# Service Bulletin 011 – 7253

**Con/Rig Tool Kit 010-0689**

Conan & Rigmaster Tool Kit 010-0689, Revision D or older

Figure 1 – 010-1117 Wrist Clamp Tool, 1 of 2

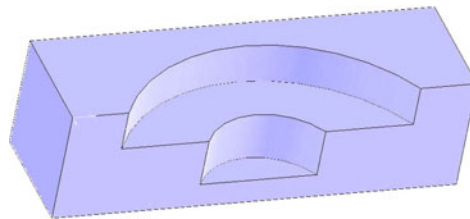
The Conan/Rigmaster Tool Kit 010-0689, revision D or older, contains only one Wrist Clamp Tool 010-1117 (see figure 1). The correct quantity is 2. The additional part will be supplied at no cost.

Inspect each Tool Kit 010-0689 and determine its revision. If the Tool Kit is **Revision D** or older, one additional Wrist Clamp Tool 010-1117 will be needed. Continue to **Part B**.

**NOTE: Revision E** or newer kits are supplied with both clamp halves, and no upgrade is necessary.
